Vermack Road + Roberts Drive Parks Master Plans

2/14/2022 City Council Presentation

To: Mayor and City Council

Re: Park Master Plans for 5435 Roberts Dr. and 4809/4819 Vermack Rd.

Vermack Road Summary of Design Changes

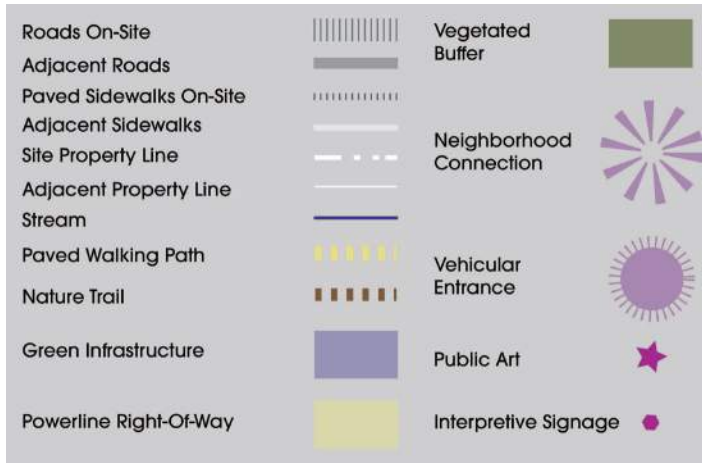
Draft Master Plan	Updated Master Plan
No interpretive signage was included in the concept.	Interpretive signage was added to the master plan concept.

Roberts Drive Summary of Design Changes

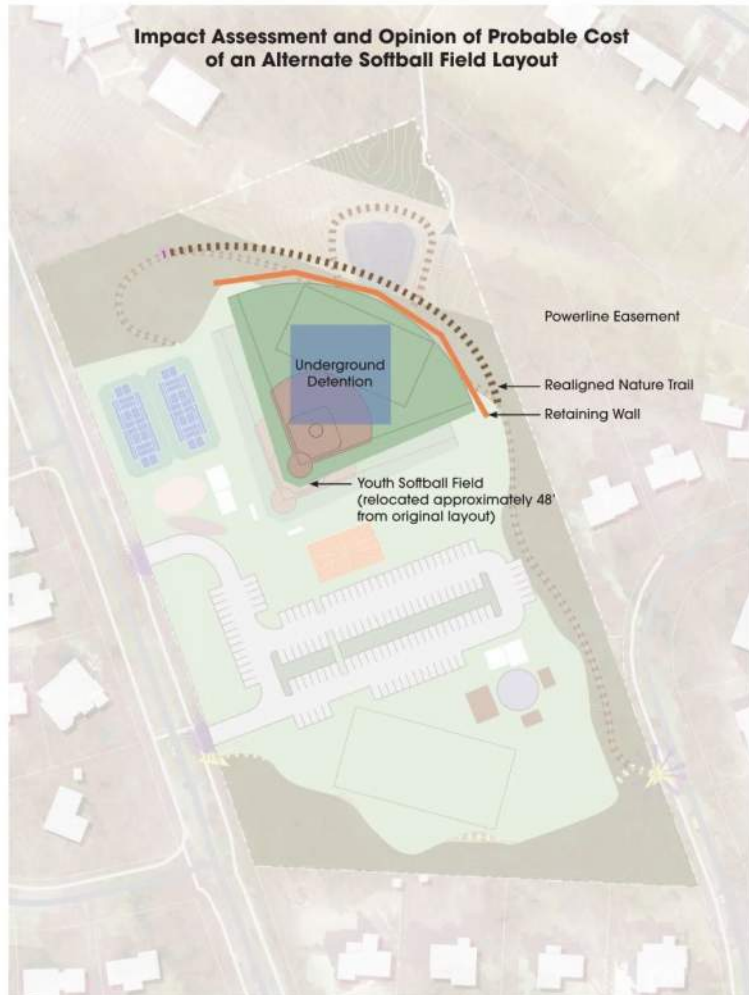
Draft Master Plan	Updated Master Plan
(2) Half-sized basketball courts were located on the northern portion of the park.	The courts were consolidated into (1) full-sized basketball court located in the central interior of the park.
The softball field was a 250 ft. adult field in the southeast corner facing the Arden Woods neighborhood.	The softball field changed to a 220 ft. youth field in the northeast corner facing the detention pond / powerline easement.
The tennis courts were oriented northwest/southeast and located on the interior of park adjacent to open play field.	The tennis courts were oriented more north/south and shifted to the perimeter of park along Roberts Drive.
Parking was located along Roberts Drive.	The parking was shifted to be primarily in interior of site. The landscape island increased in size to allow for more plantings.
The open play field, splash pad and supporting facilities, and playground were located on northern portion of park.	The open play field, splash pad and supporting facilities, and playground were shifted to the southern portion of park adjacent to the Arden Woods neighborhood.

The vegetated buffer was unchanged between concepts.	In addition to maintaining the buffer, a native planting meadow was added along Roberts Drive and the southern edge of the park.
The entry plaza, concession stand, and restroom facility was located in the central interior of the site.	The entry plaza, concession stand, and restroom facility were relocated closer to Roberts Drive along the main drive.
No wildflower plantings were included in the concept.	Wildflower plantings were added along the walking loop and along Roberts Drive.
The concept did not include interpretive signage.	Interpretive signage was added throughout the site.
